Bid 627
New HVAC Modernization Project for (Both) Oxnard and Pacifica High Schools

BID CLARIFICATION ADDENDUM #3

Dated: August 25th, 2020

DRAWING NUMBER: **AK4.0**

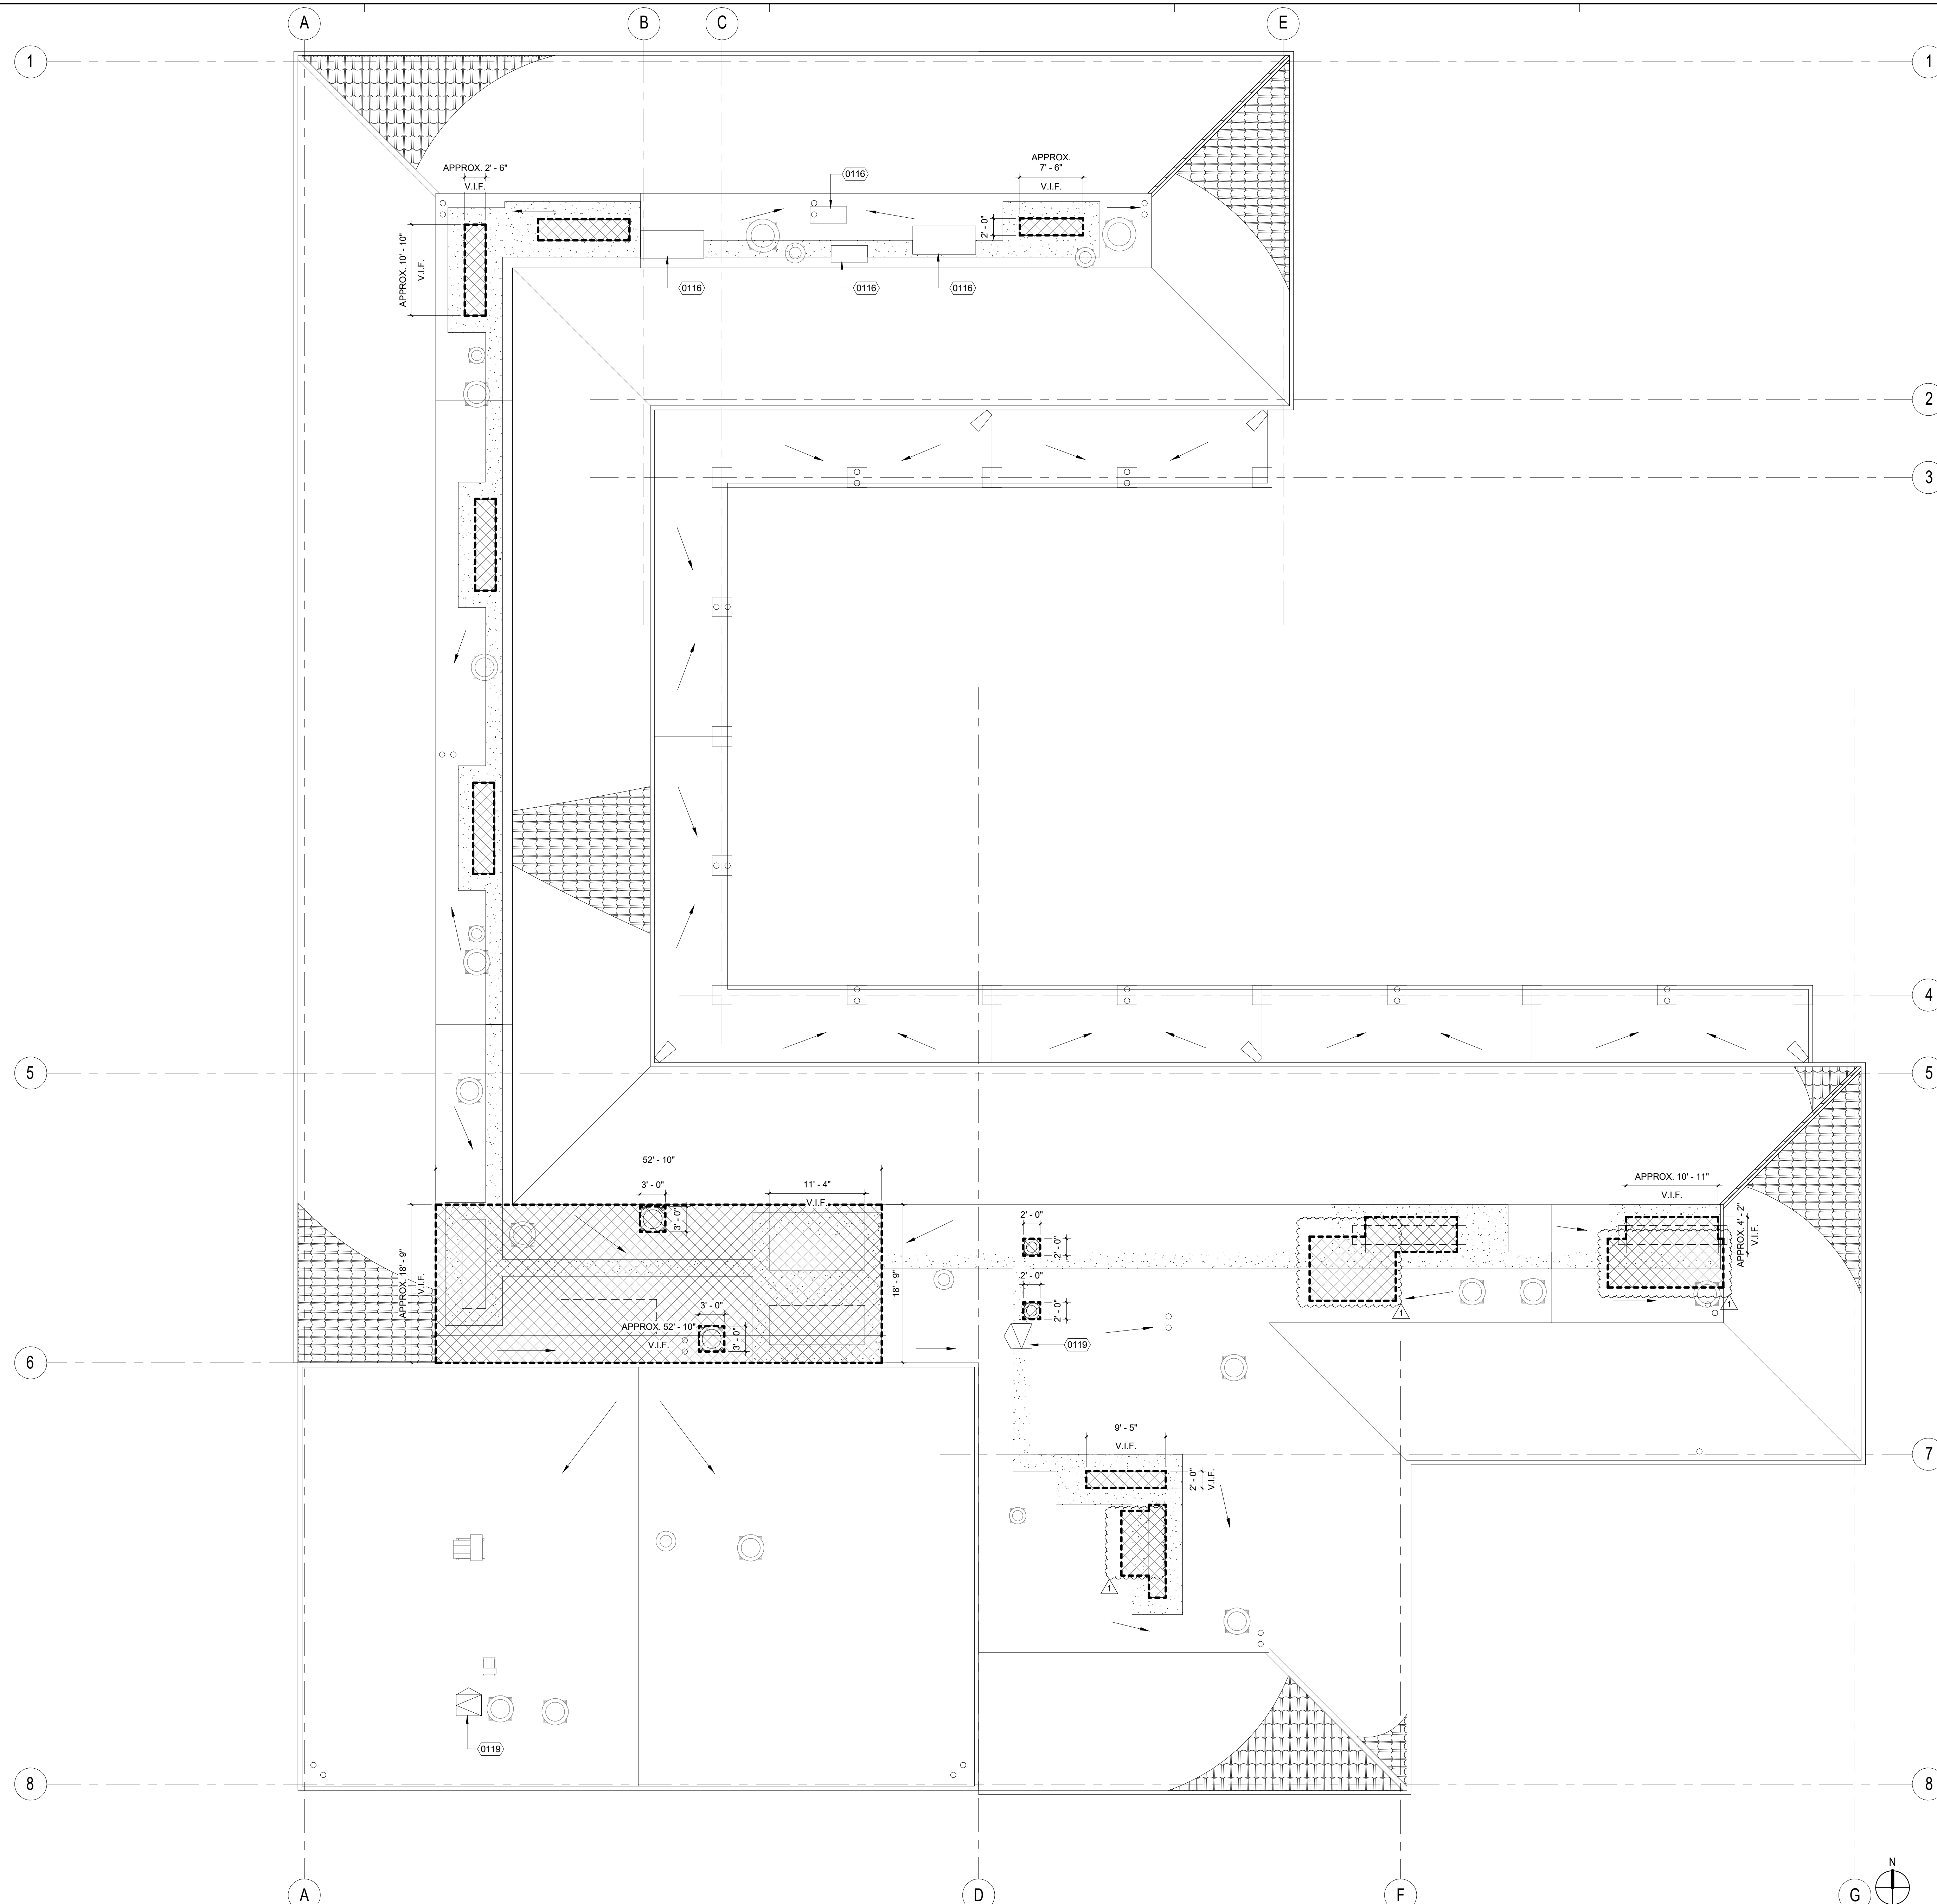
- A. Replace DSA approved Drawing AK4.0 in its entirety with the attached revised Drawing AK4.0 (Relocated package unit and added additional area for roof removal).

DRAWING NUMBER: **AK4.1**

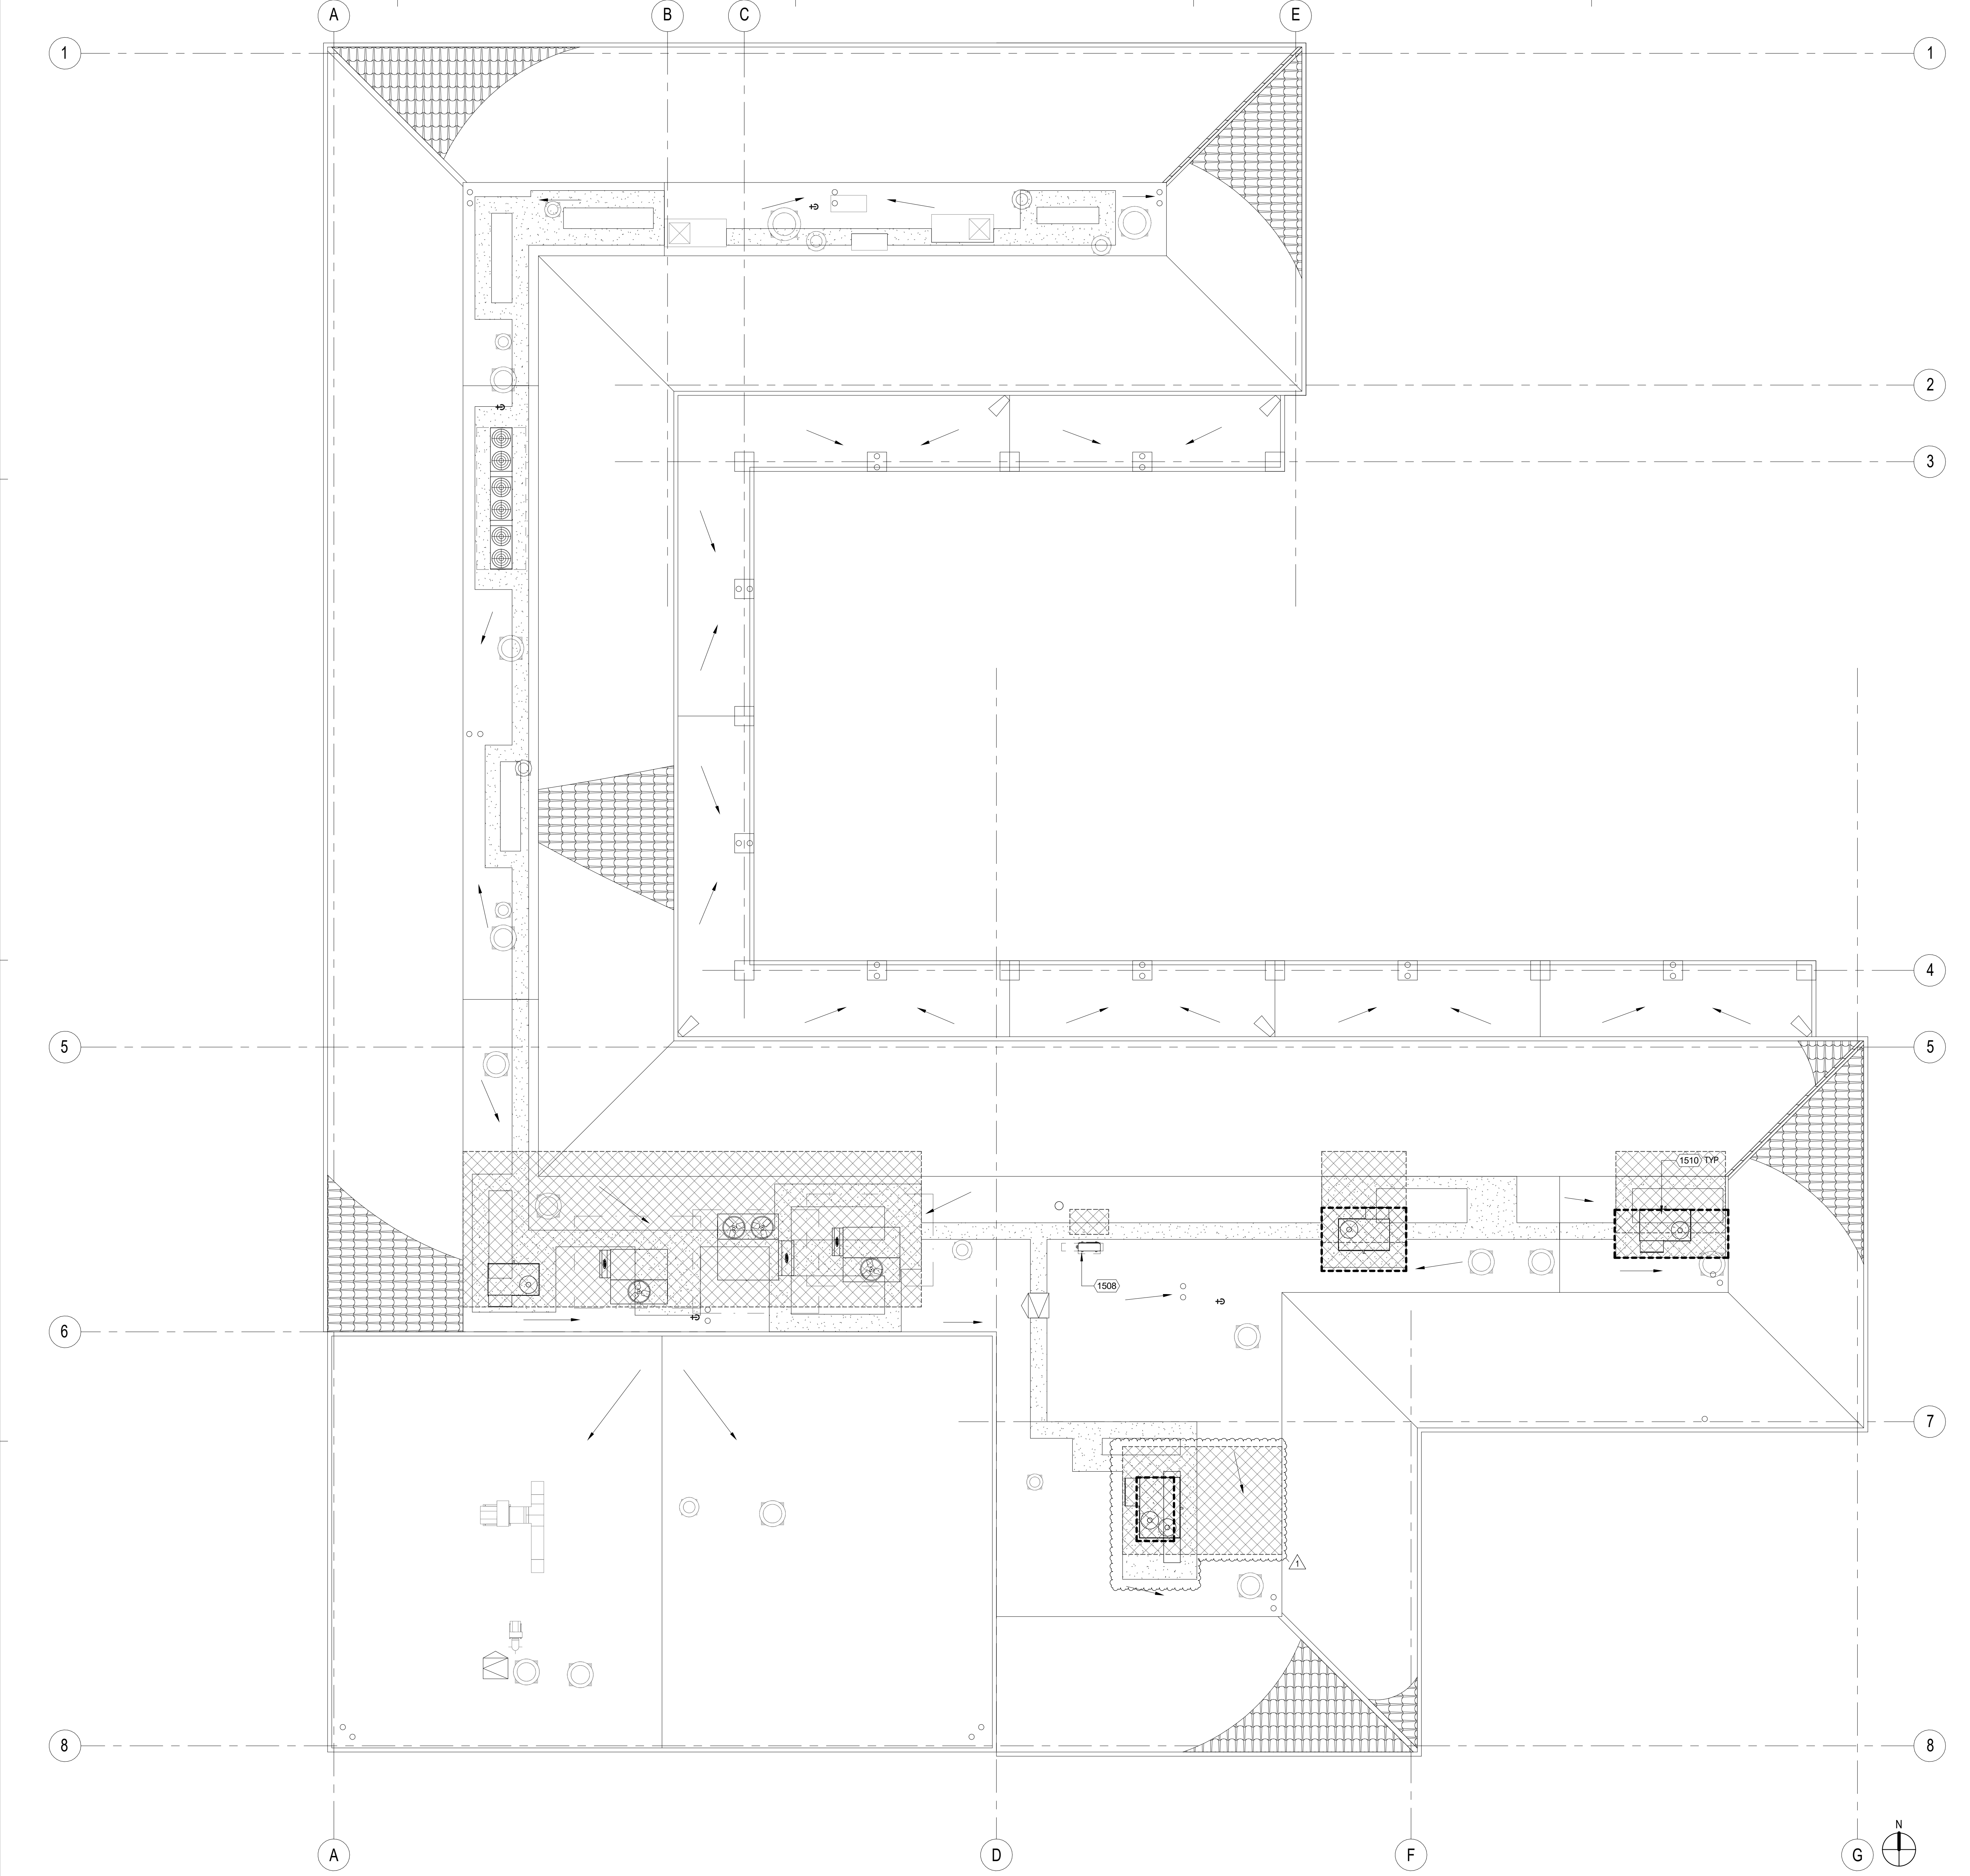
- A. Replace DSA approved Drawing AK4.1 in its entirety with the attached revised Drawing AK4.1 (Relocated package unit and added additional area for roof replacement).

DRAWING NUMBER: **S2.8**

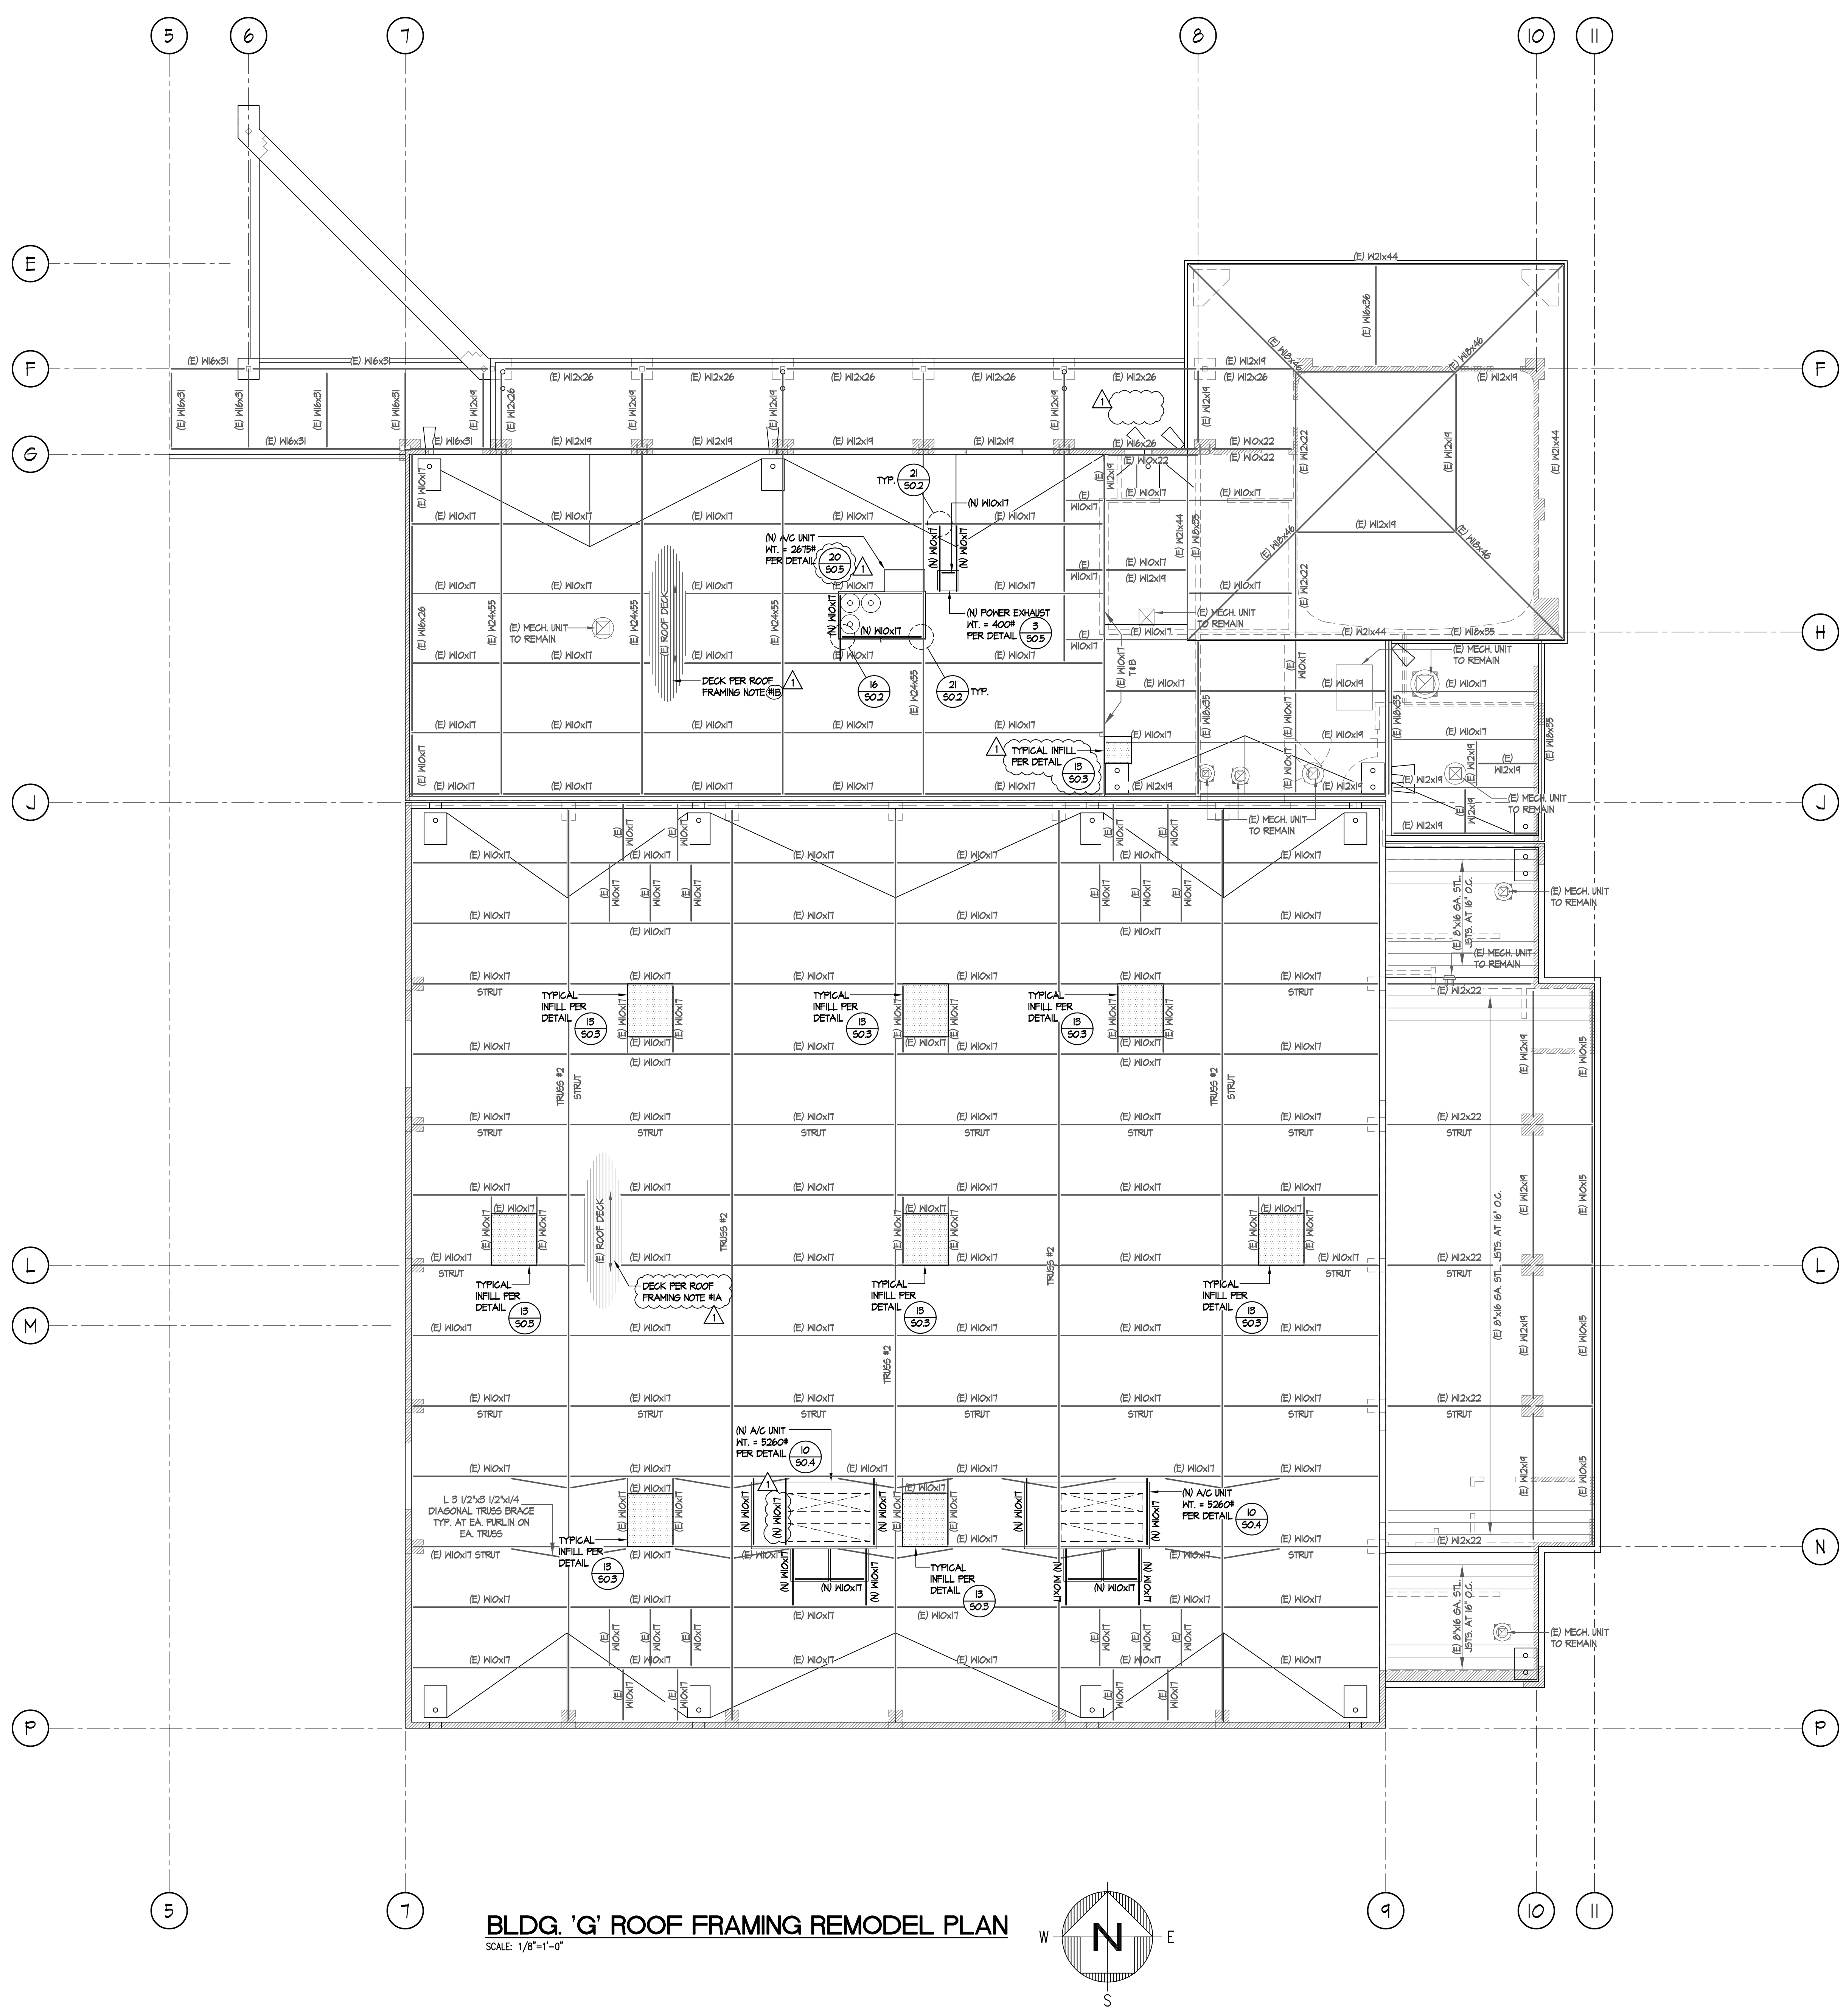
- A. Replace DSA approved Drawing S2.8 in its entirety with the attached revised Drawing S2.8.
- B. ROOF FRAMING PLAN
 1. Removed note for unit to be demolished.
 2. Added typical deck infill at demolished mech unit.
 3. Revised deck callout.
